ULPOWER AERO ENGINES N.V.

SERVICE BULLETIN

Service Bulletin No. 2017-01

SUBJECT: installation guideline for oil coolers

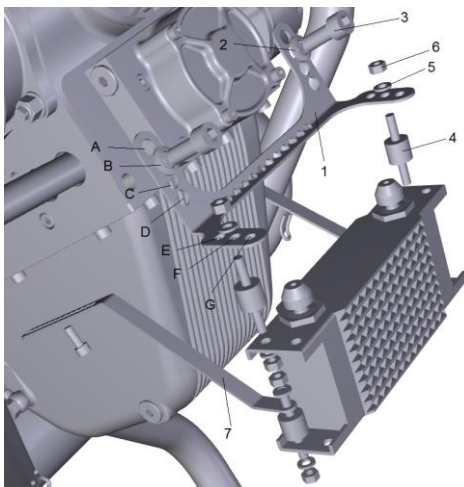
Recently our supplier changed the installation guidelines for the oil coolers with ULPower part numbers E0426107 – E0426110 – E0426113 – SE0426205 – SE0426116.

Consequently, we changed the guidelines in our installation manuals.

Please install 4 shock absorbers as shown on the drawing below. (part n° 4).

Even if you have installed our oil coolers in another way, make sure to insert shock absorbers.

If you prefer to buy them at a local store, look for a shock absorber of 15mm with M6
